PARTIAL BASEMENT FLOOR PLAN - NEW WORK

ADDENDUM #4 IFB-6569A

YONKERS PUBLIC SCHOOLS
BUILDING RENOVATIONS AND
SITework AT
SCHOOL 9

SHEET NO: M100A

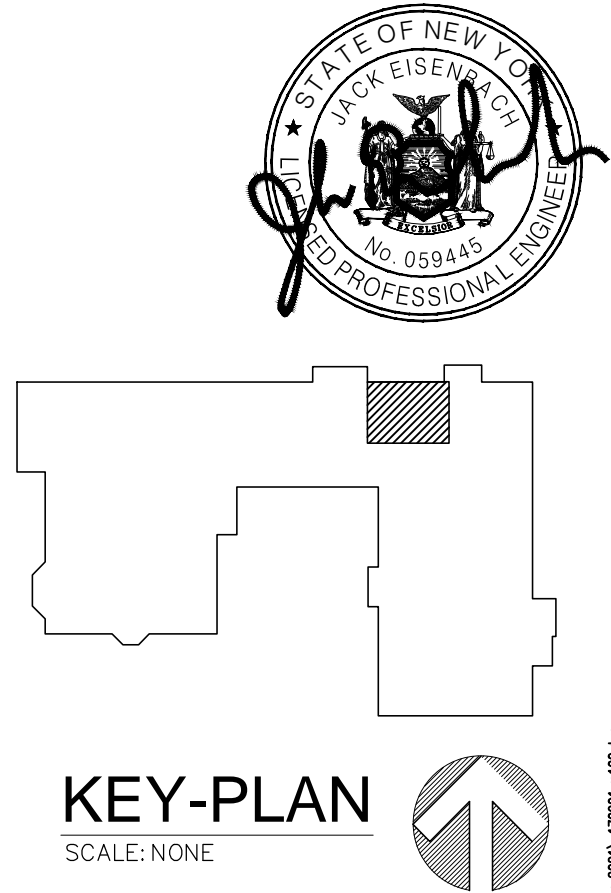
1 PROVIDE NEW CABINET HEATER AND APPURTENANCES AS SCHEDULED.
